11 Chris Bang Crescent, Vaucluse NSW 2030

OBJECTION to Section 4.55 - Application for Modification of Development Consent
Application DA-206/2016/B

6. FRONT FENCES

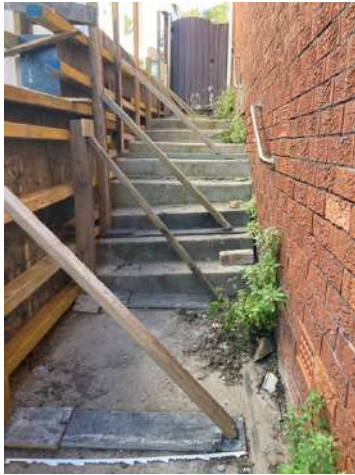
The original architectural plans showed no fences to the proposed street boundary and this was re-clarified in the amended plans, that were subsequently approved by council. Below please find a picture that shows the front walls that have been erected in the street boundary and on council land. No permission was given by council to enclose part of council land.
